# Addendum

**Project:** Harris County Psychiatric Center Renovation  
Units 1C, 2E, 3B, 3C, 3D, & 3E

**Addendum No.:** 002

**Date:** November 14, 2016

**A8.01**

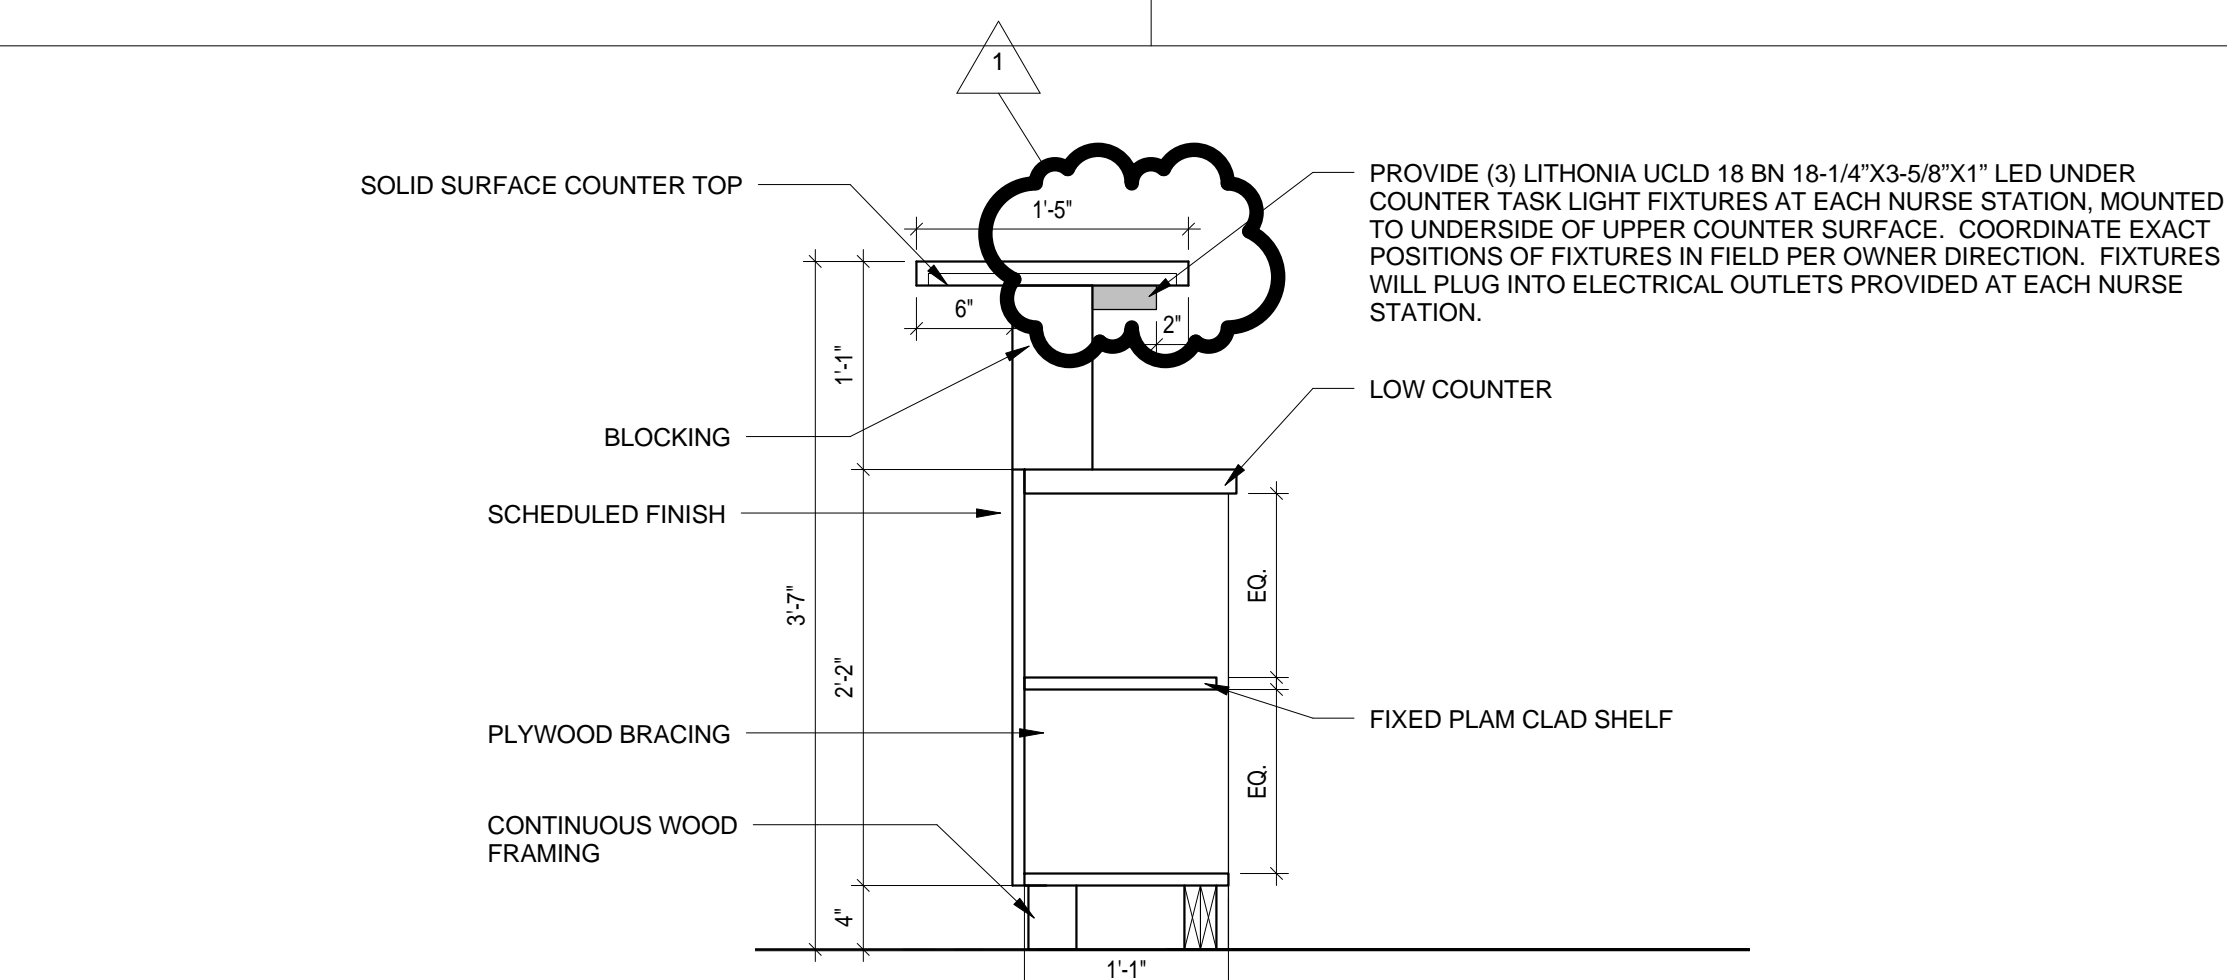
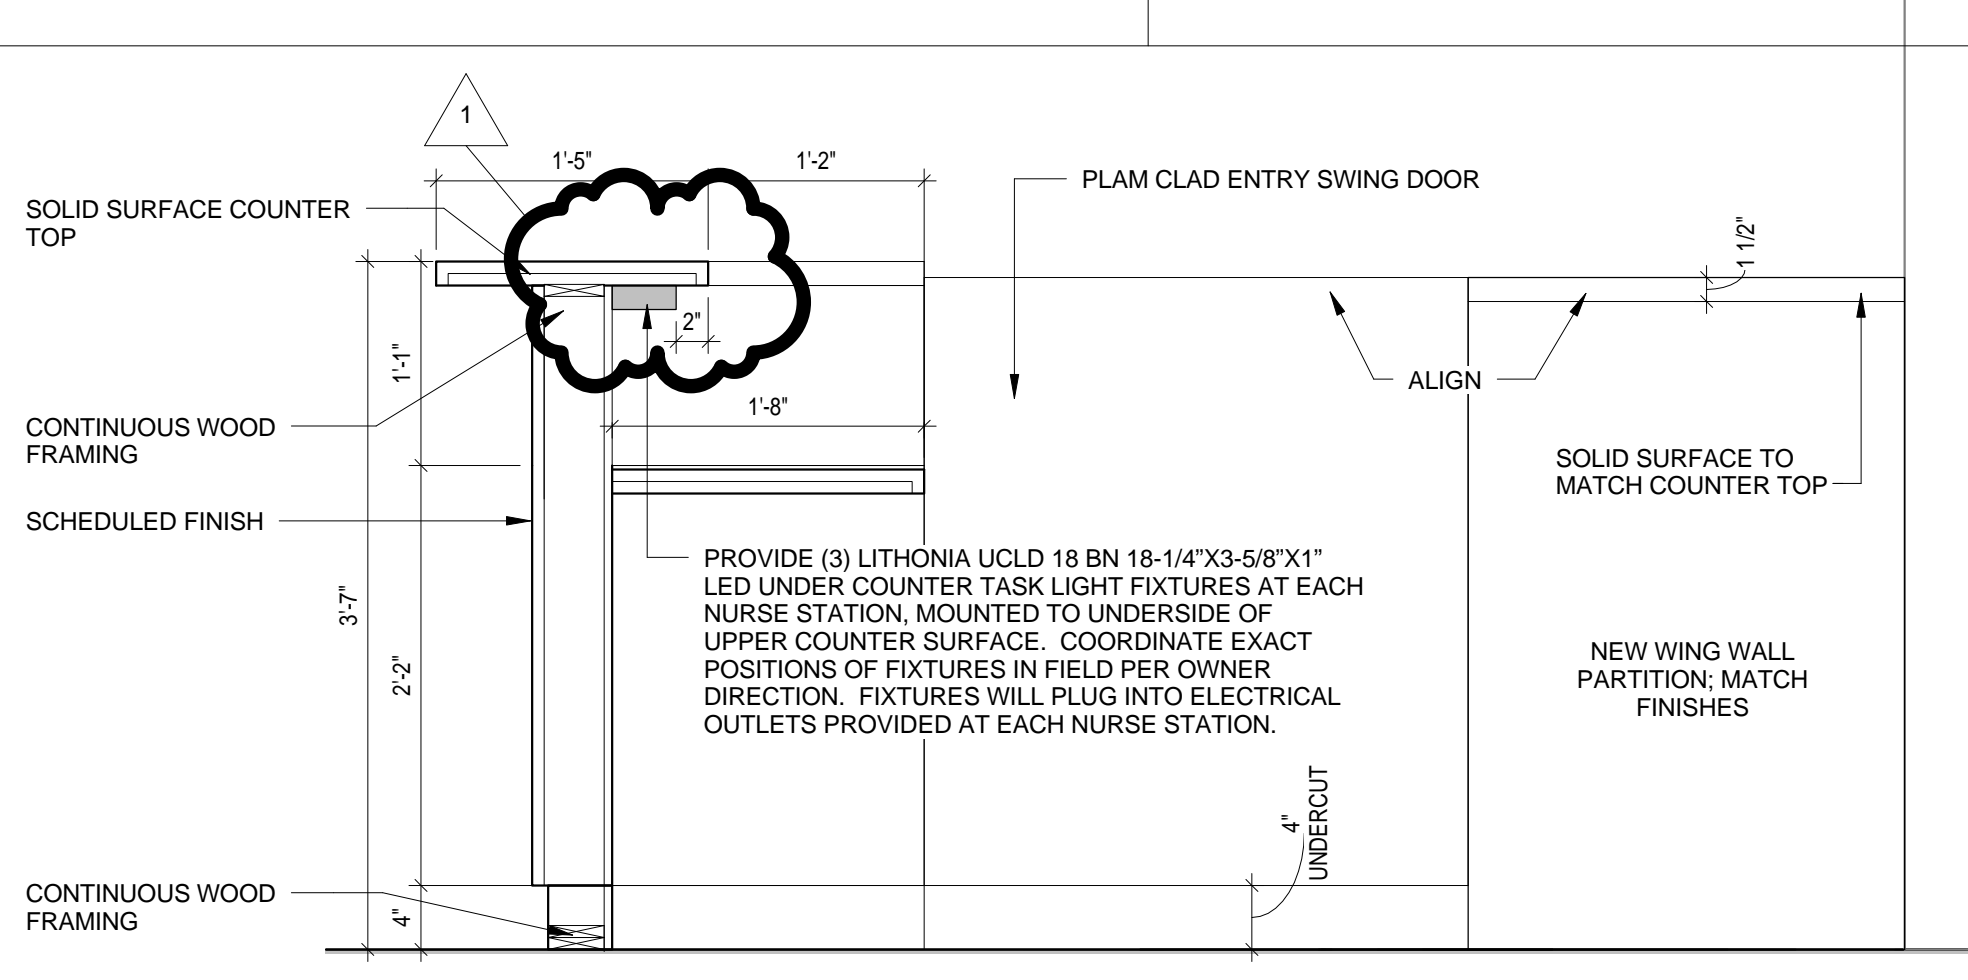
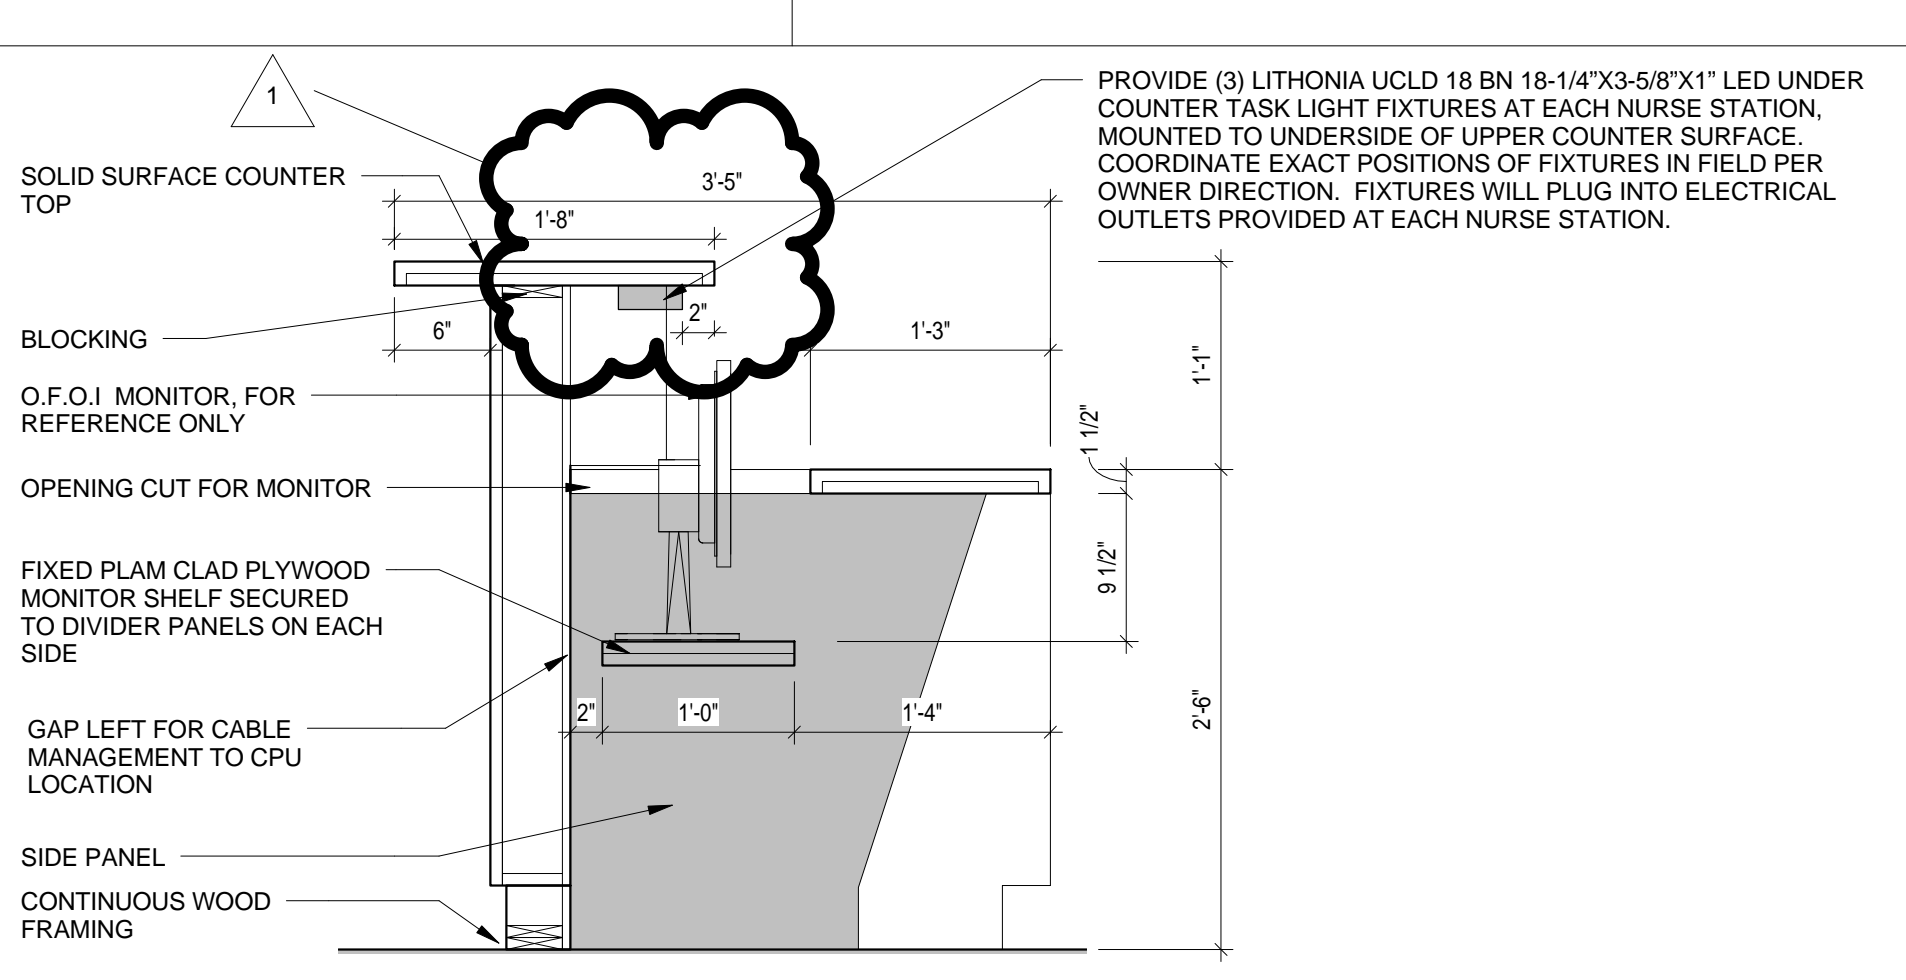
13. Sheet A8.01, Millwork Sections, revised to reflect the addition of under-counter task lighting at each Nurse Station millwork section detail. (see attached)

**A10.01**

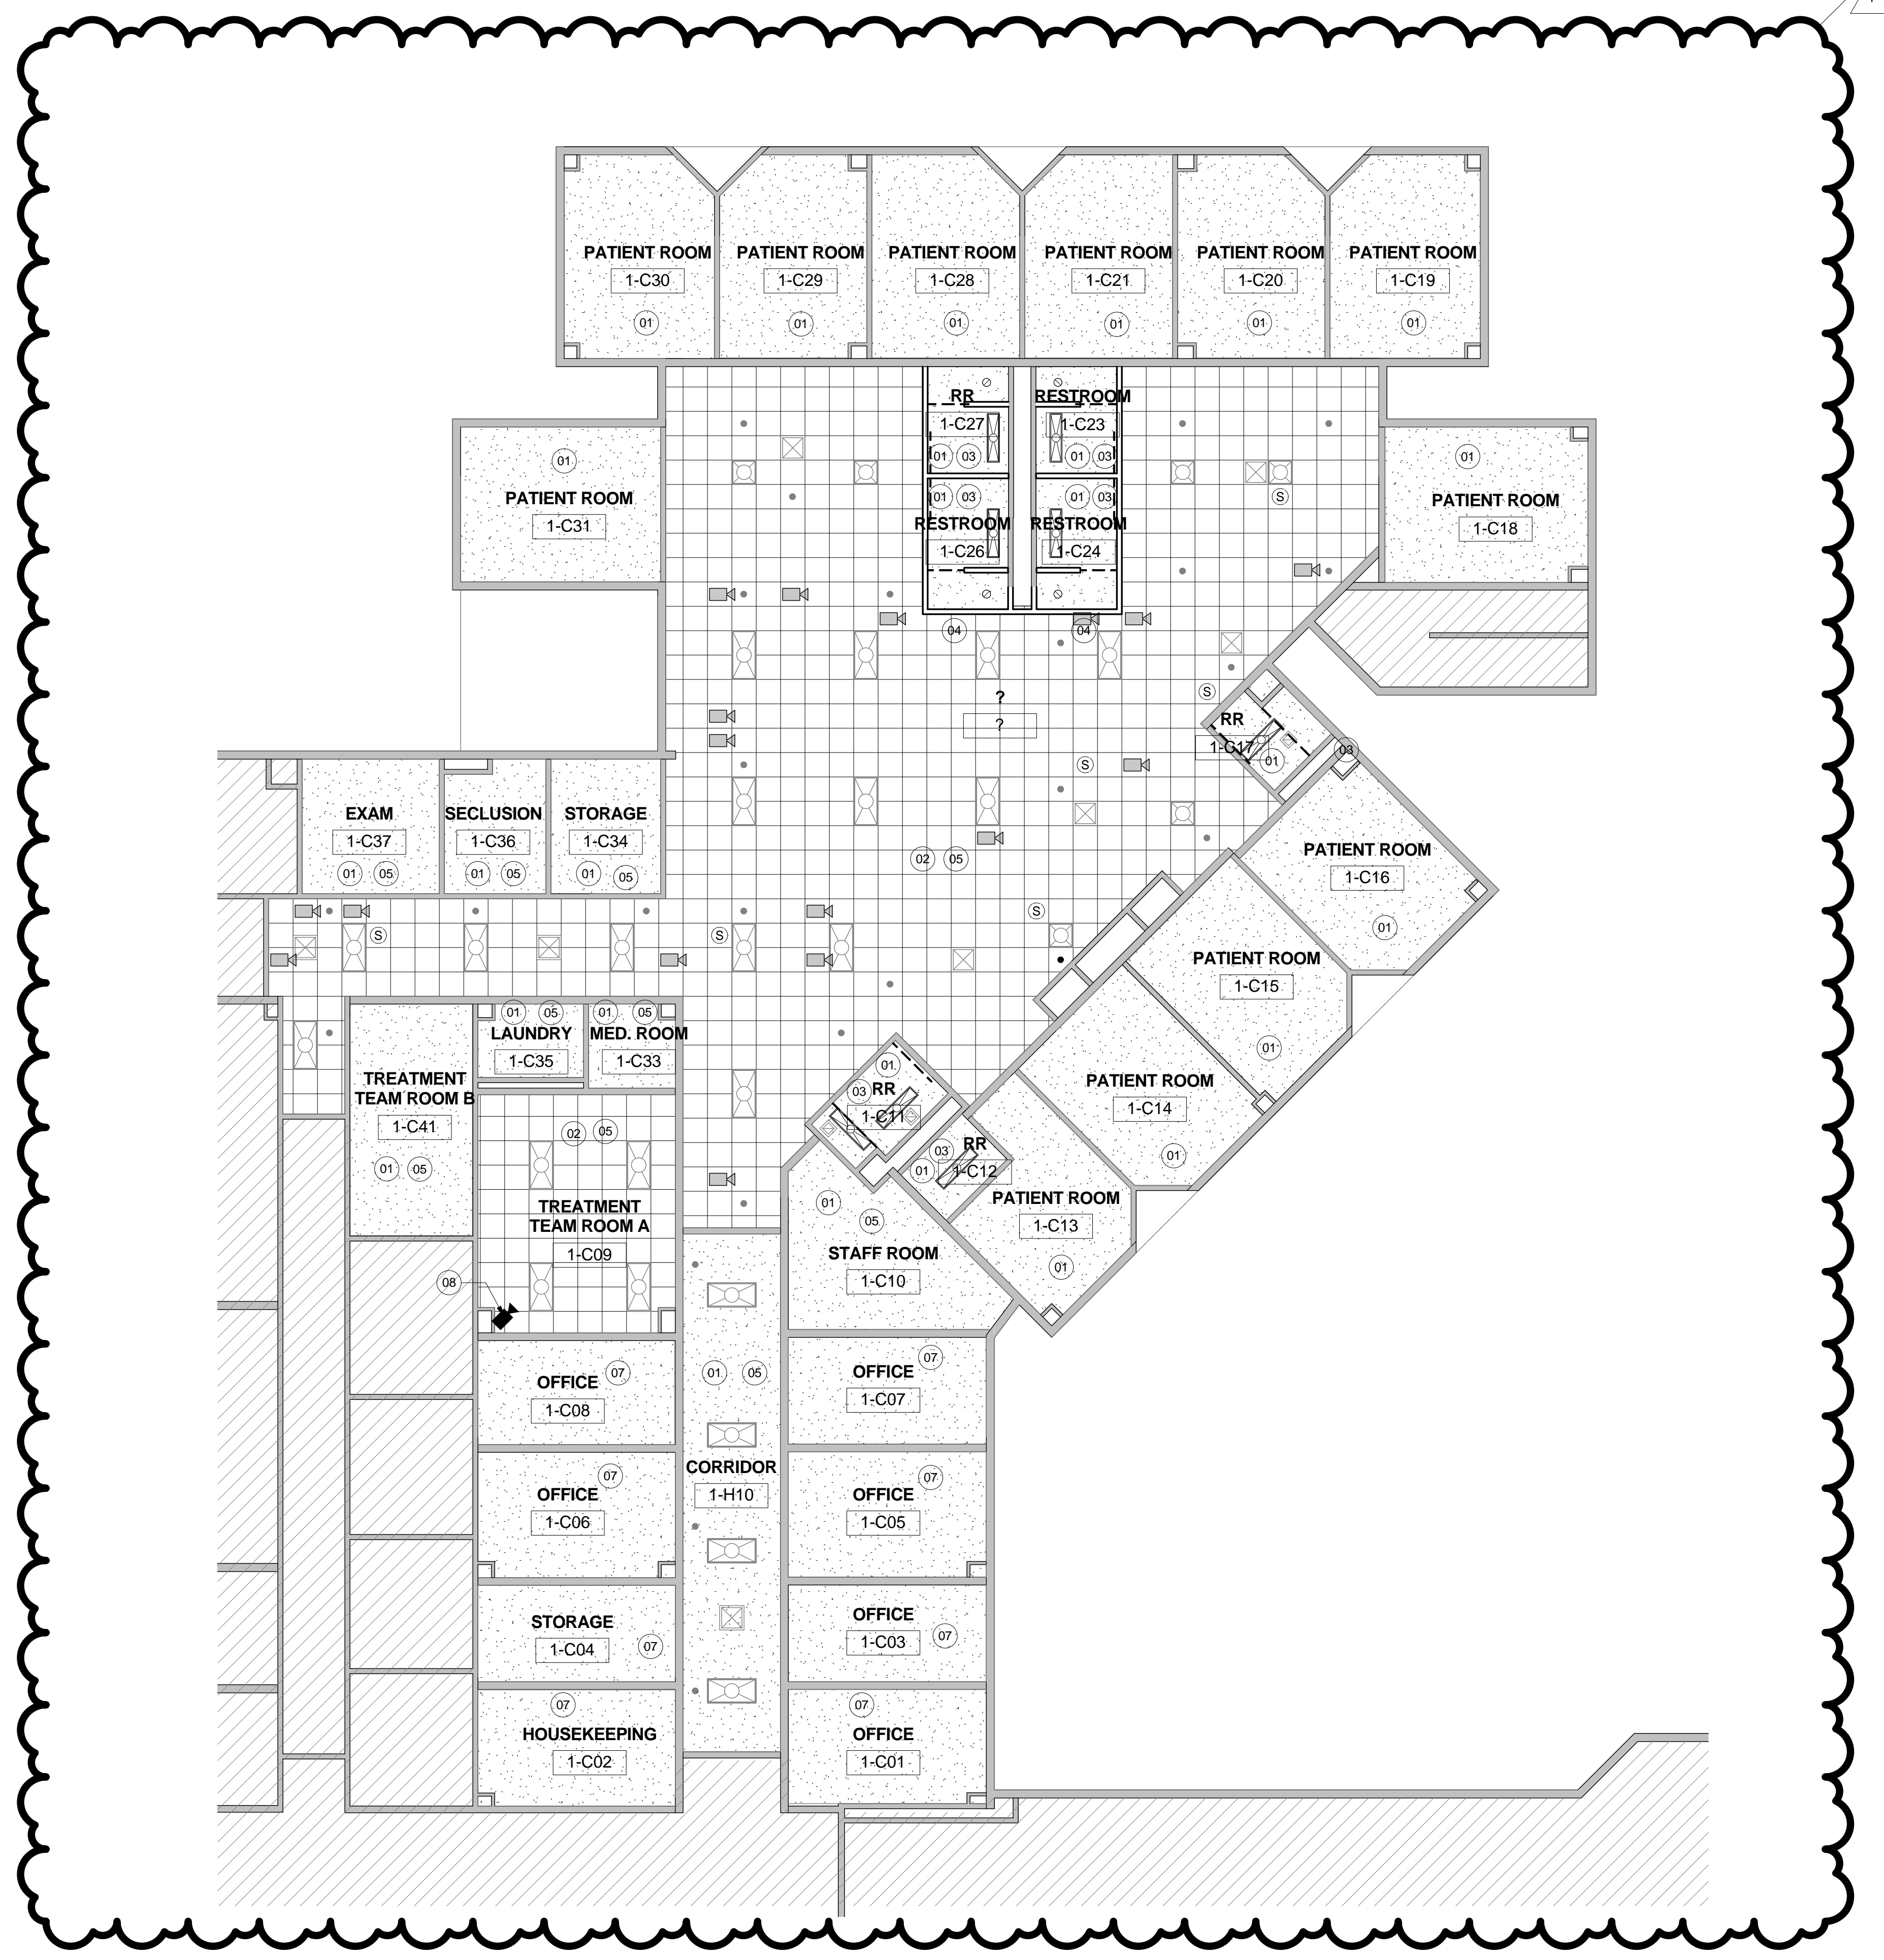
14. Sheet G0.04, Fire Alarm Devices, added to Drawings for reference only.
15. Sheet A10.01, Reflected Ceiling Plan – Unit 1C First Floor, revised to reflect changes to keyed note text and placement on the reflected ceiling plan in order to provide additional clarification regarding the scope of work pertaining to existing and new light fixtures throughout the unit. (see attached)
